<b>ADDENDUM NO. :</b>	<b>Four (4)</b>
<b>BID DUE TIME AND DATE:</b>	2:00 p.m., April 30, 2019 <b>(No Change)</b>
<b>BIDDER QUESTIONS BY:</b>	11:59 a.m., April 23, 2019
<b>LAST ADDENDUM ISSUED:</b>	11:59 p.m., April 25, 2019

**THE PURPOSE FOR THIS ADDENDUM IS:**

- **To provide a response to questions raised by Plan Holders;**
- **To modify/clarify specifications and drawings.**

**A303**

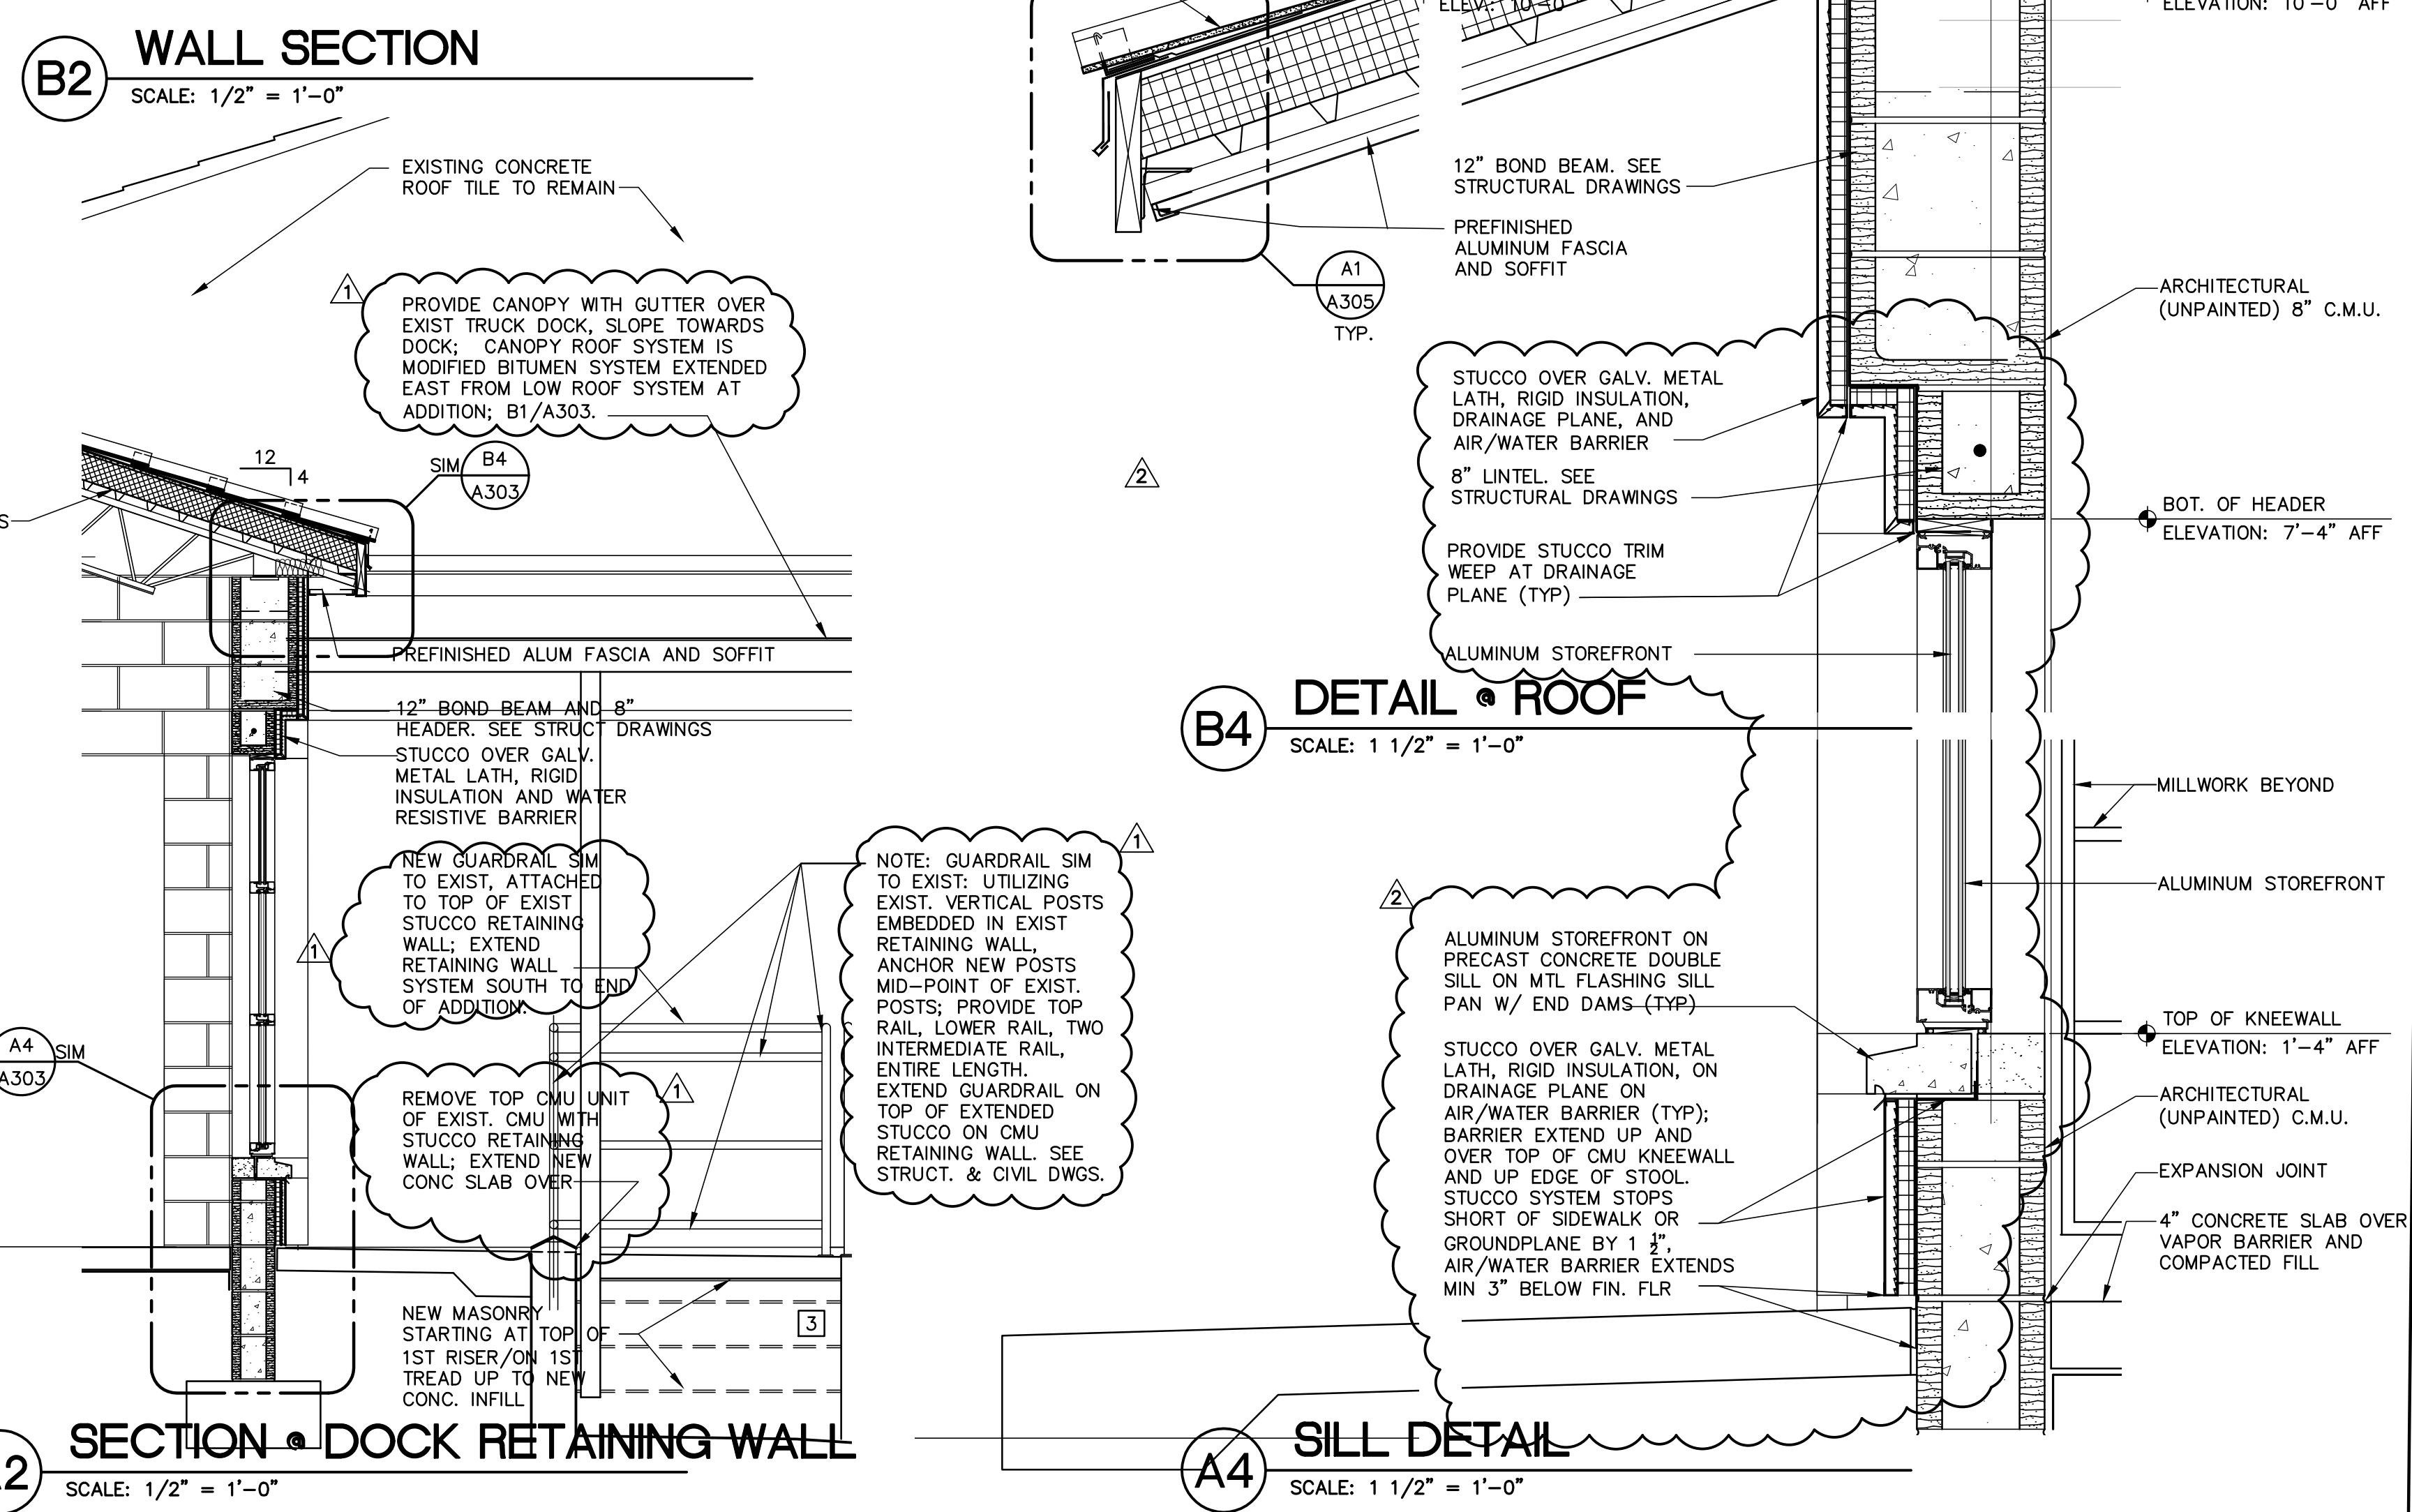
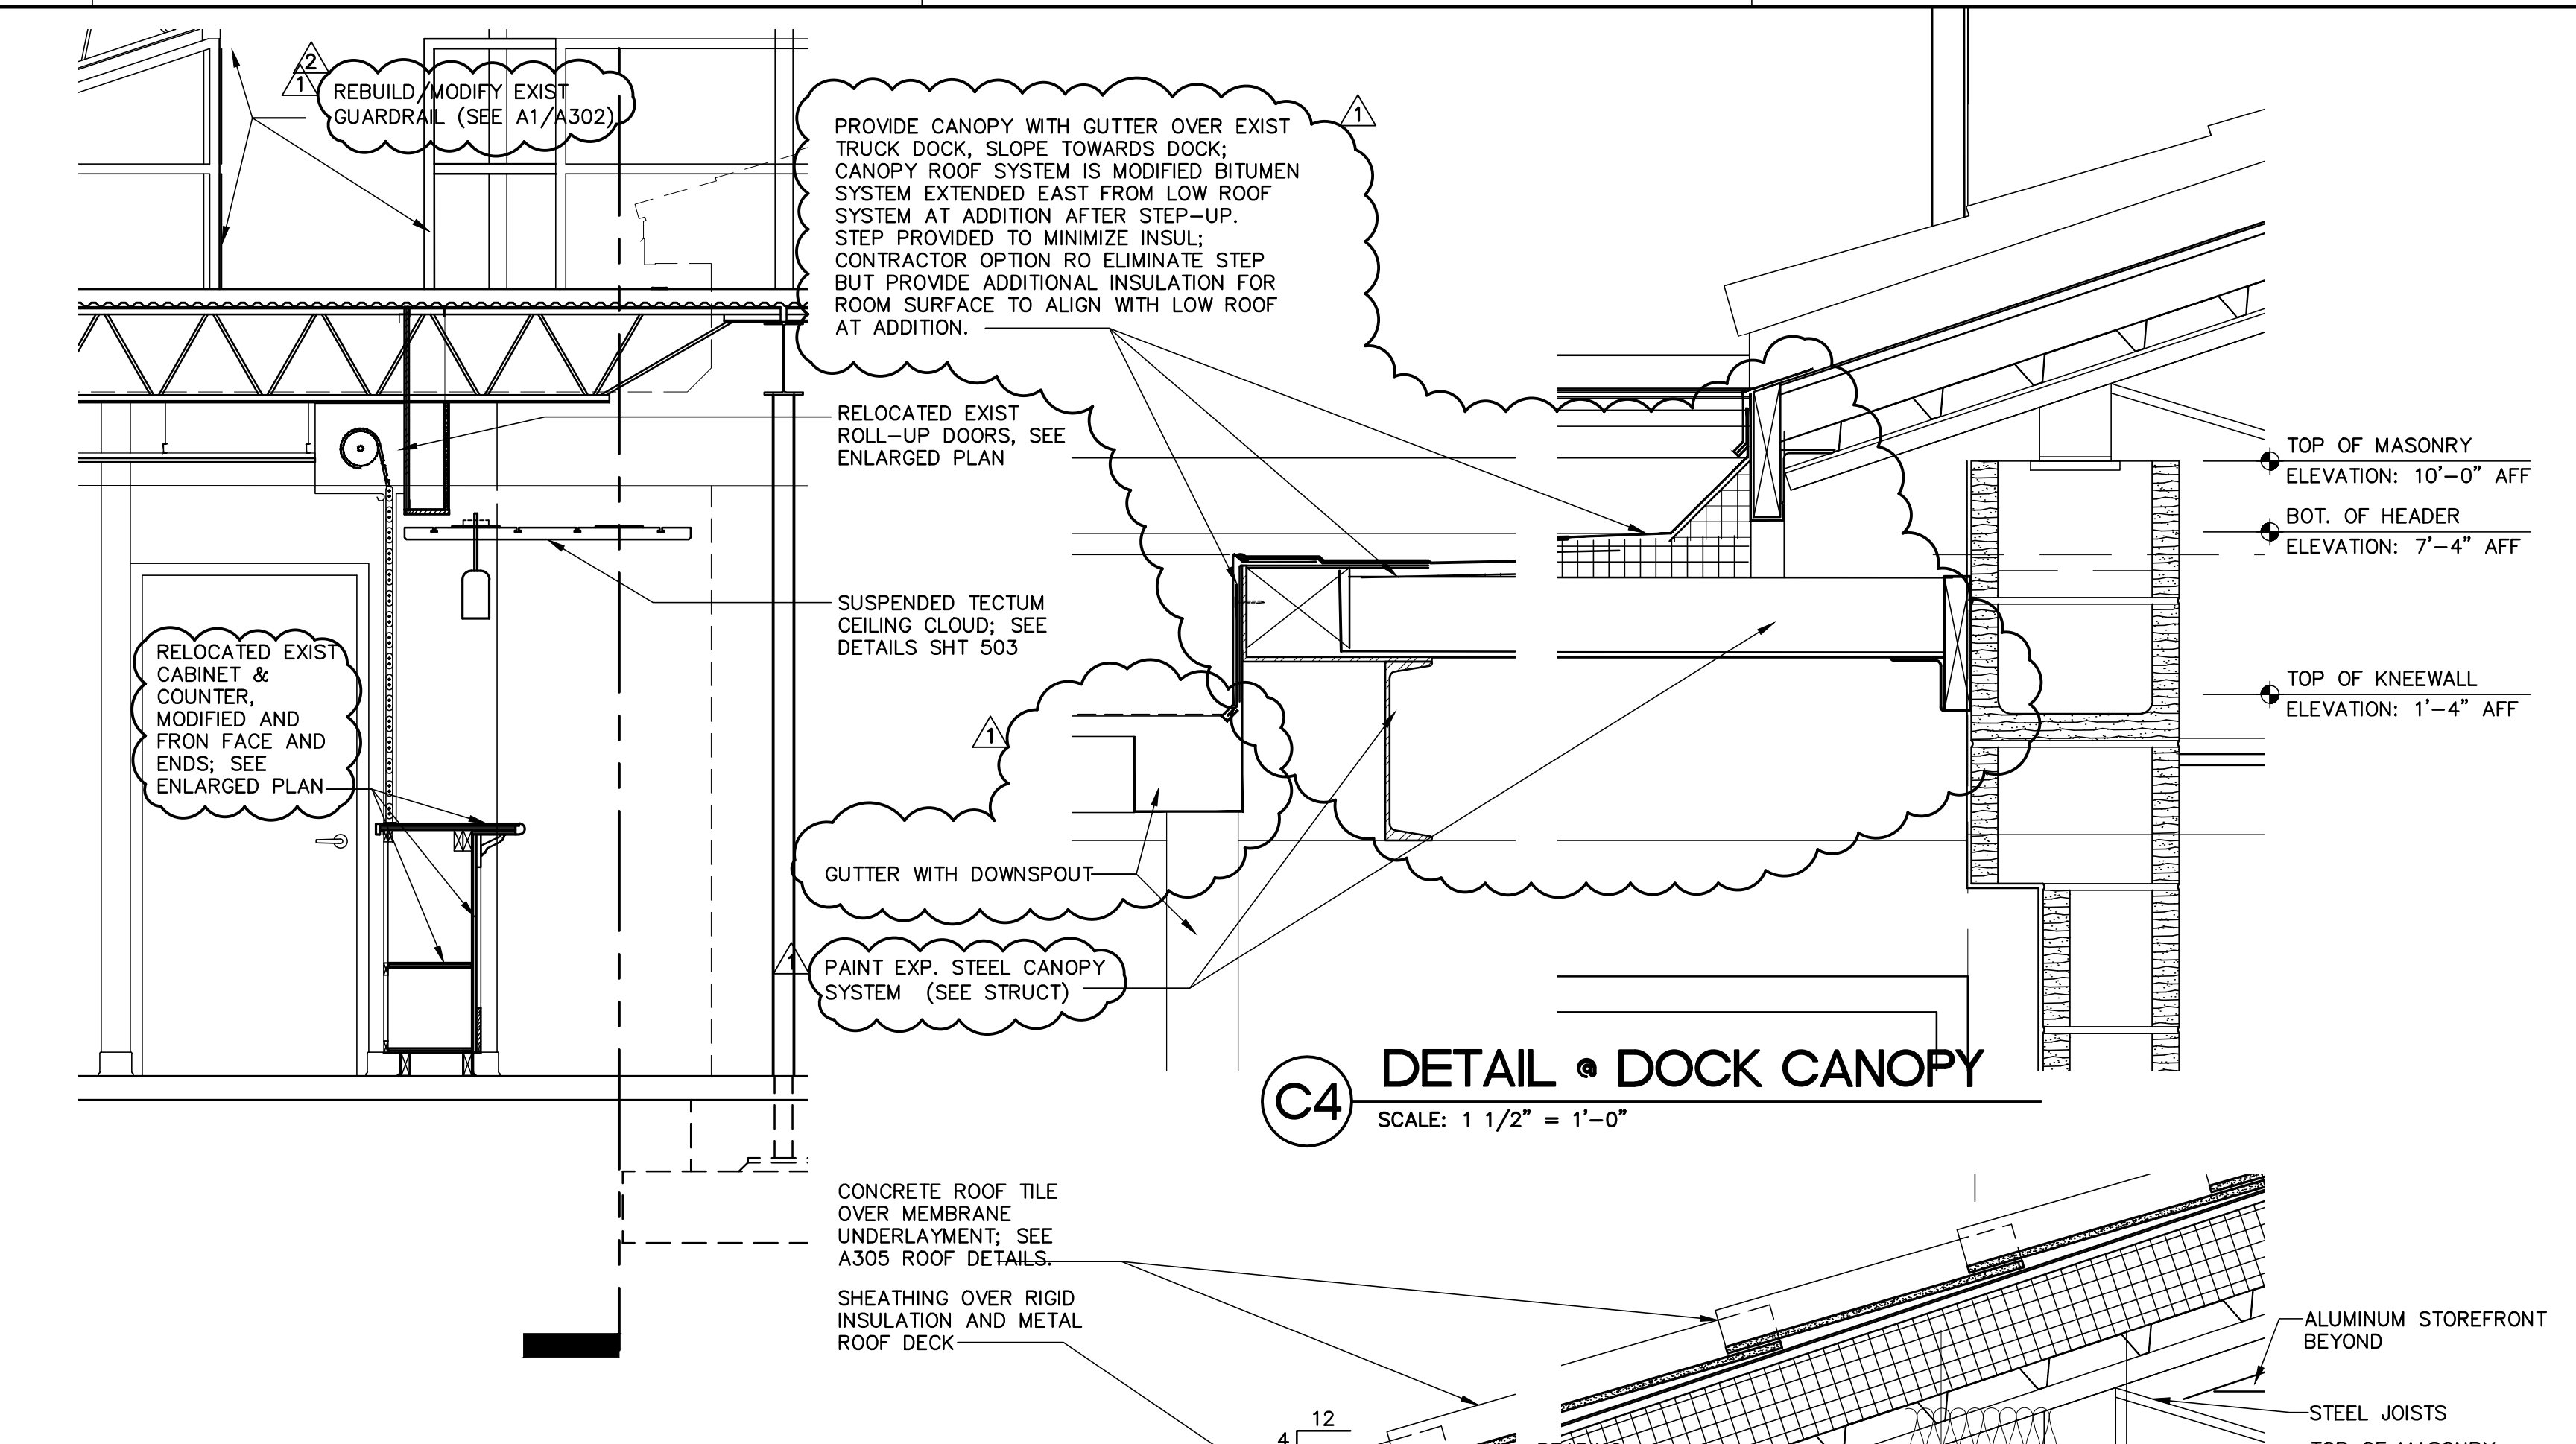
- Clarification on the wall types (section on acoustical separation, 2 hr, and detail at top of 10' wall) and ceiling cloud detail(s) and finish details such intent of columns for exposed electrical on CMU
- HVAC details such as air handler coil connection (what's needed re isolation valves, strainers, etc.)
- Extent of chilled water line treatment
- Specs/detail on OA louver to be installed within storefront (shown on HVAC, visible on Section A301, not A202 or A602)
- Redundancy on, and revisions to a few Hardware items; see hardware Spec sections attached.
- Sections clarified to indicate sill pan, as well as location of drainage barrier; all sections at stucco clarified to show weep at base of drainage plane. Additionally, simplify cast sills.

- A301 Building Sections
- A302 Building Sections
- A303 Ext Wall Sections & Details
- A304 Ext Wall Sections & Details
- A306 Ext Wall Sections & Details
- A502 Ceiling Details
- A601 Finish Schedule w/ Details
- P101, Updated plan to show missing fixtures and missing sanitary and vent piping
- P102, Updated plan to show missing fixtures, missing domestic water piping and missing gas piping
- P101, Updated plan to show missing fixtures and missing sanitary and vent piping
- P201, Updated plan to show missing fixtures and missing sanitary and vent piping
- P202, Updated plan to show missing fixtures, domestic water piping and missing gas piping
- M401, Added detail for chilled water connections to AHU
